ZONING COMMITTEE STAFF REPORT

1. **FILE NAME:** Victoria Park Apartments Phase 3 **FILE #** 16-015-194
 2. **APPLICANT:** Nova Classical Academy **HEARING DATE:** March 24, 2016
 3. **TYPE OF APPLICATION:** Appeal of a Planning Administrator decision
 4. **LOCATION:** 763 Kay Ave, SW corner at Mercer Way
 5. **PIN & LEGAL DESCRIPTION:** 142823210045, Victoria Park Lot 1 Blk 6
 6. **PLANNING DISTRICT:** 9 **PRESENT ZONING:** T3M
 7. **ZONING CODE REFERENCE:** §66.344(c); §61.701
 8. **STAFF REPORT DATE:** March 17, 2016 **BY:** Bill Dermody
 9. **DATE RECEIVED:** March 3, 2016
-

- A. **PURPOSE:** Appeal of Planning Administrator approval of changes to the Victoria Park Master Plan to allow a 49 ½ ft. high apartment building.
- B. **PARCEL SIZE:** 160 feet (Kay Avenue) x 142 feet (Mercer/Victoria) = 22,720 square feet

VICTORIA PARK - PHASE III
PRELIMINARY SITE PLAN

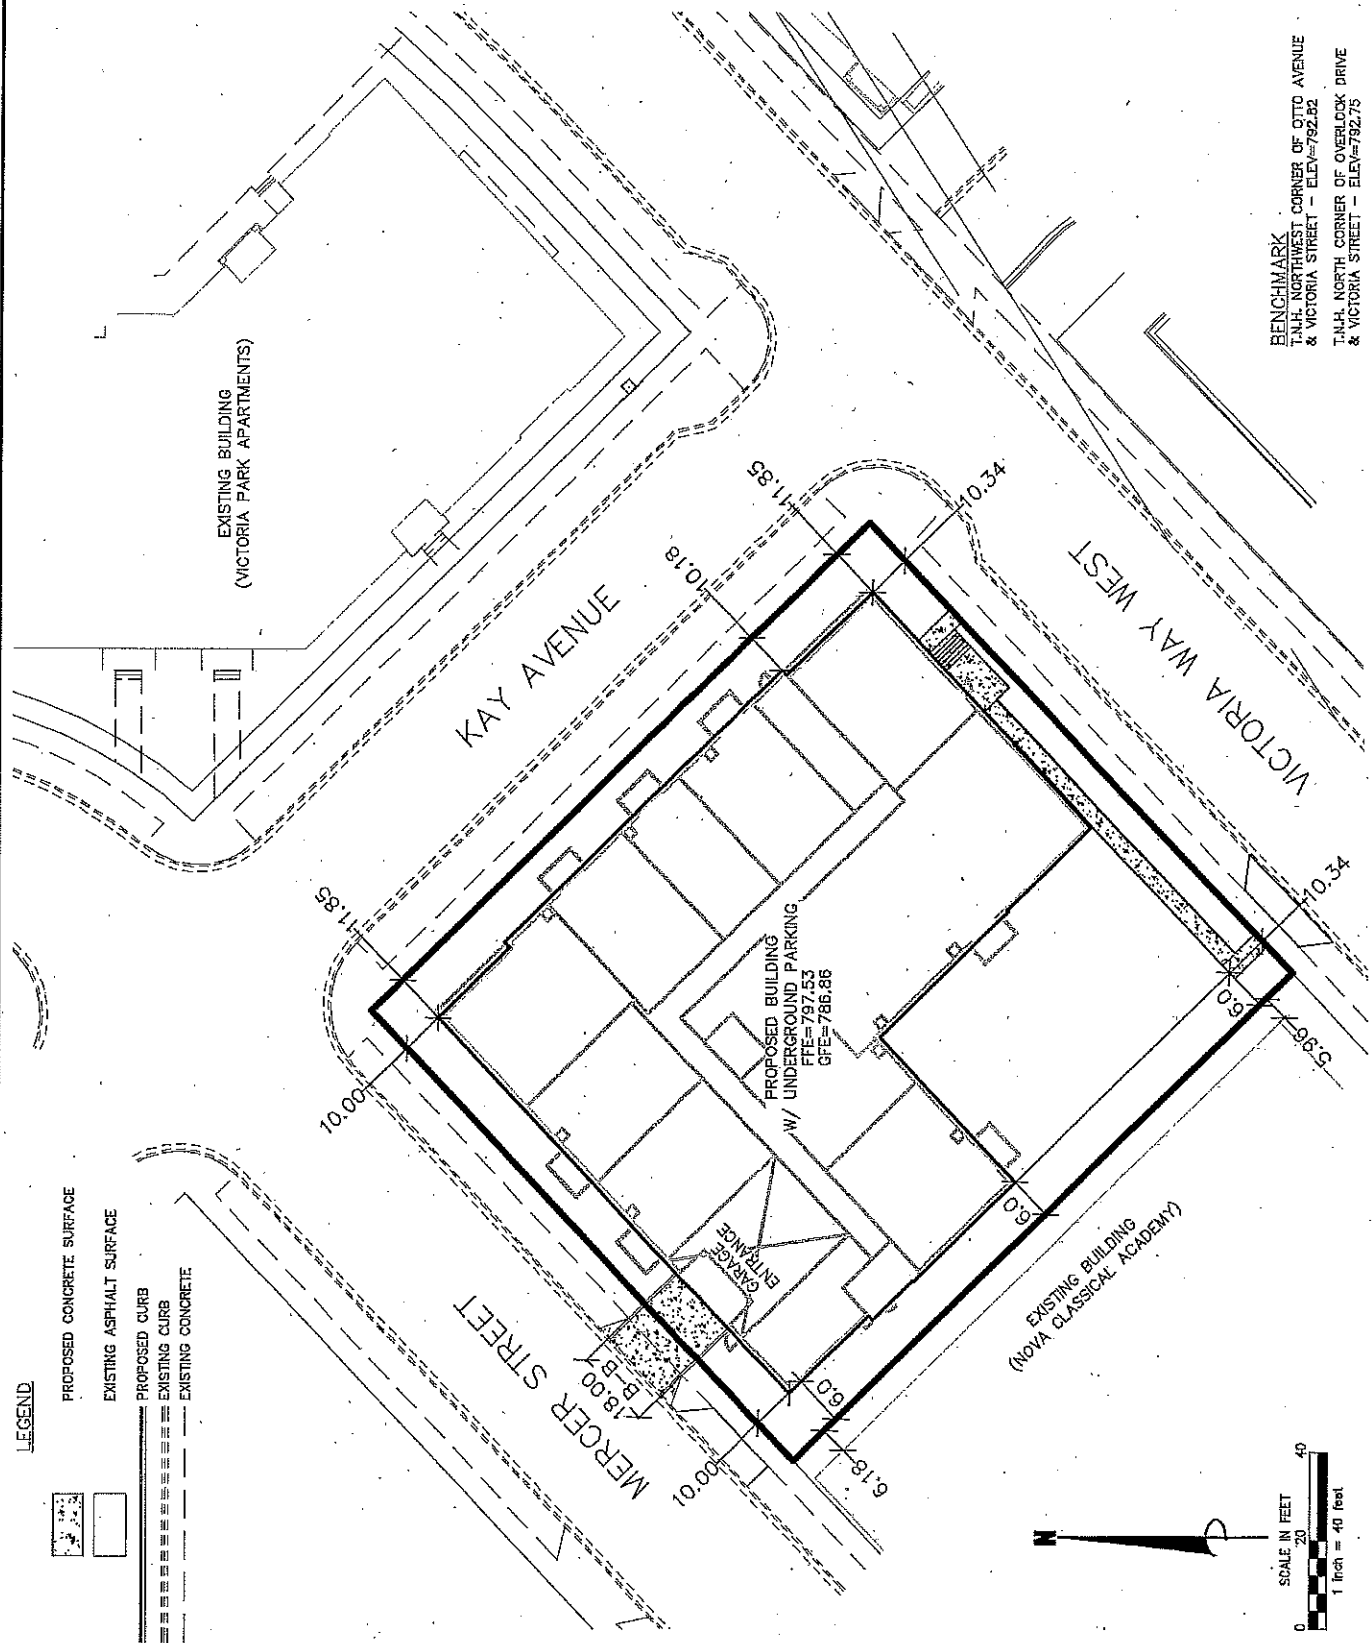
The current plan for the apartment building puts the driveway (entering and exiting from their proposed underground garage) onto Mercer Street. This will create significant problems. Before Chase Development is granted permission to deviate from the Master Plan and add not 13 cars but 50 to this particular spot in Victoria Park, a traffic study needs to be completed, both to assess ways to remedy the impact on vehicle traffic and also to assess the impact on pedestrian safety, especially as pedestrian-friendliness is one of the explicit goals of the Master Plan.

There are several ways traffic problems could be remedied. First of all, Mercer Street could be widened (there is an undeveloped piece of land bordered by Mercer Street and Kay Avenue) although this would go against some of the principles of a traditional urban neighborhood as discussed in the Master Plan and make the area less friendly to pedestrians. Mercer Street could also be restricted to one-way traffic. Possibly some of the problems could be alleviated by moving the entrance/exit for the underground parking to Kay Avenue, although Kay Avenue is also quite busy during drop-off and pick-up for the school and shift changes for Shalom Home. Or the development could be kept to the original plan of townhomes rather than apartments. (Probably several of these solutions will be needed.)

Plate 7
 Building Type

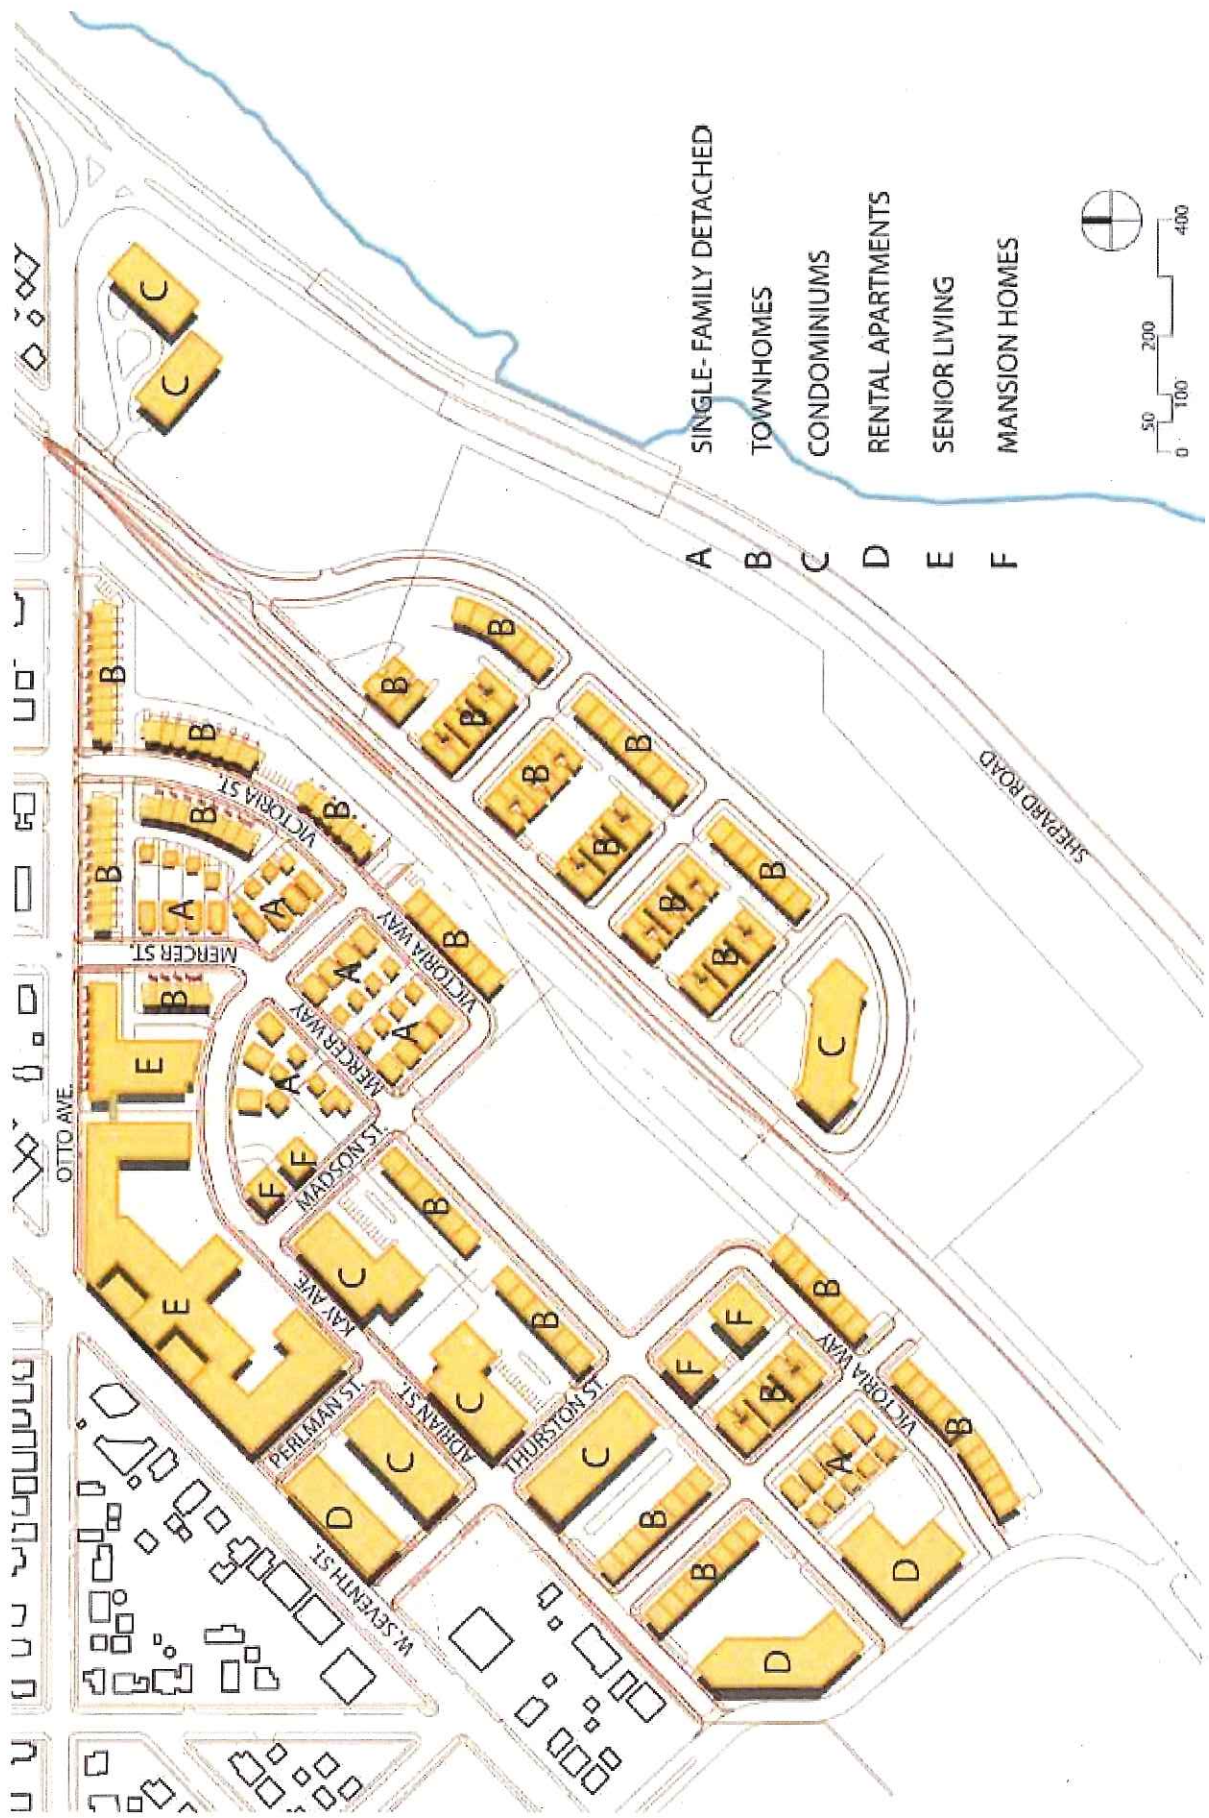
* The Master Plan states, "There is a range of housing types, prices and styles." Plate 7 of the Master Plan shows townhomes and single-family detached houses along Mercer Street and Victoria Street. There are no single-family detached houses, and only a small number of townhomes; mostly those streets are filled with apartment buildings. Now Chase proposes to add yet another large apartment building. To meet the goal of variety, the neighborhood urgently needs more townhomes and detached houses. The whole purpose of master plans is to balance the preferences of developers with an approach that meets the needs of the neighborhood in the long term.

The building layout per Plate 7 at our Phase 3 property indicates a u-shaped 'townhomes' development. After reviewing several site plan options, we determined the proposed L-shape building to provide the most functional and useful floor plan and the most respectful in providing additional setback from the adjacent Nova School building. Square buildings are more suitable for offices and very difficult for housing. Having such a small site available (122' x 140' in useable building footprint), we see underground parking and **apartment homes** as the highest and best use of the property. The corner courtyard will add visible features like canopies, planters and landscaping for a nice experience to pedestrians passing by.

3. The Victoria Park Master Plan's land use category of Mixed Residential (as shown in Plate 6) is not being changed, and so the threshold of 10% land area change that would constitute a major plan modification is not met. Also, the change in building type (Plate 7) from townhomes to apartments is consistent with the master plan's intent, including as stated in Core Design and Planning Principle #1 ("The site is urban in character, in terms of block size, block arrangement and density."), Principle #4 ("There is a range of housing types, prices and styles."), and Principle #5 ("The neighborhood is well-designed so that relatively high densities are provided in medium-rise, human-scaled buildings."). Therefore, due to both the lack of land use category change and consistency with master plan intent, the change in building type constitutes a minor modification of the Victoria Park Master Plan.

Plate 8
Maximum Building Heights

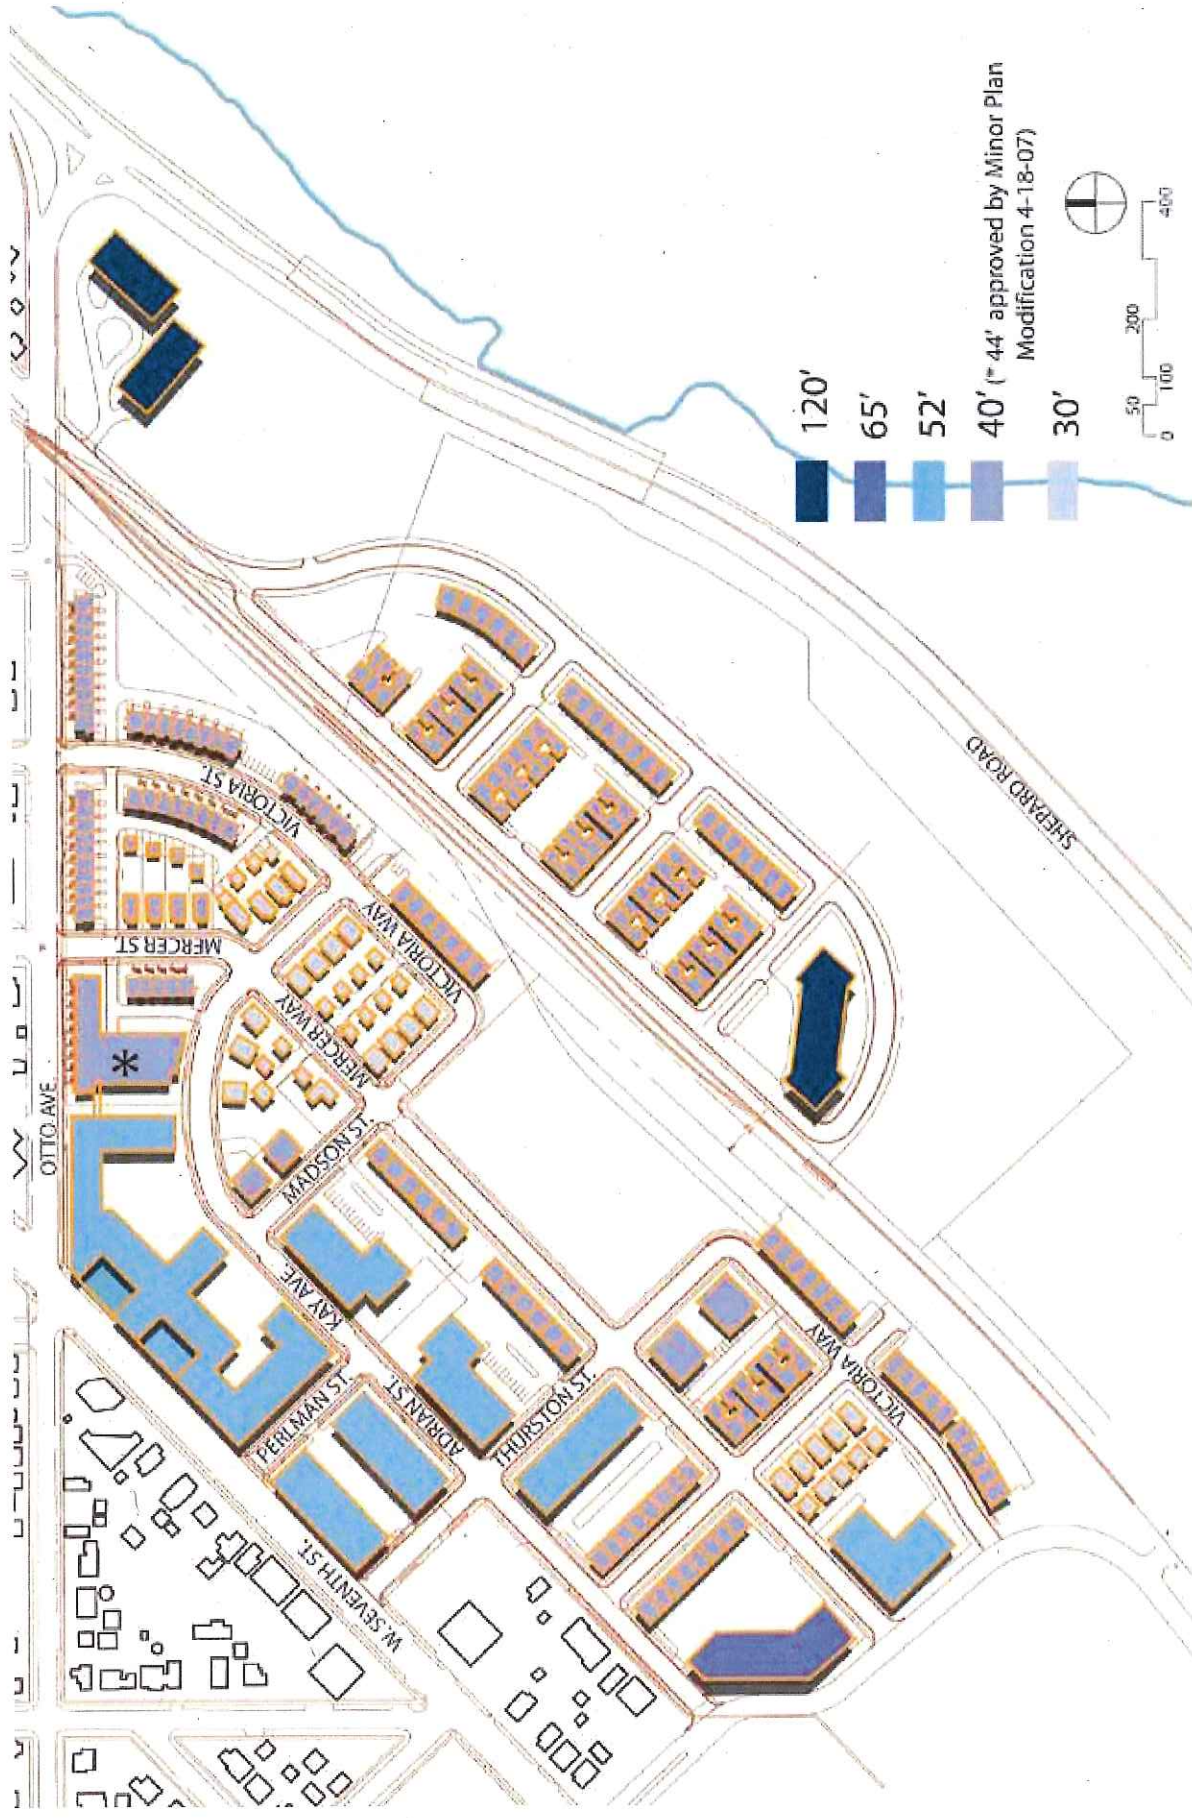
This letter is to request a minor plan modification to the Victoria Park Master Plan (adopted and amended August 2011) to allow a height increase of 9'-1 1/2" above the permitted 40'-0" at this location per the Master Plan's Plate 8: 'Maximum Building Heights'. The master plan notes that "*Victoria Park will range from 2-10 stories, with most buildings in the 2-4 story range*". We are also proposing market-rate apartment homes versus 'townhomes' per Plate 7: 'Building Type'. Please see below for further clarification:

The height of the building at its tallest point as measured per zoning code (from top of highest roof down to average grade plane height) is 49'-1 1/2". (See attached elevation). This request for increased height will meet the Victoria Park master plan in designing for residential buildings primarily in the 2-4 story range. The extra height requested is needed to construct a typical apartment building having 9'-0" ceilings. With a typical floor-to-floor height of 11'-0" in wood constructed buildings, in addition to a roof parapet and a Level 1 Floor stepped above outside grade, typical 4-story buildings are several feet taller than 40'. The proposed design (see elevation) shows a taller front entry corner with a higher brick parapet, and then stepping down to a 47'-1 1/2" height.

4. The proposed increase in height from 40' to 49'6" allows for one additional story for the residential use, totaling approximately 13 additional residential units. The additional units constitute approximately a 2% increase in residential units for the master plan area, which is a minor change that is consistent with the master plan's intent.

5. A building height increase is not included in the list of changes in §66.344(c)(2) that constitute a major master plan modification, and the change in maximum building height for this site from 40' to 49'6" is not similar to the changes listed in §66.344(c)(2) as constituting a major master plan modification.
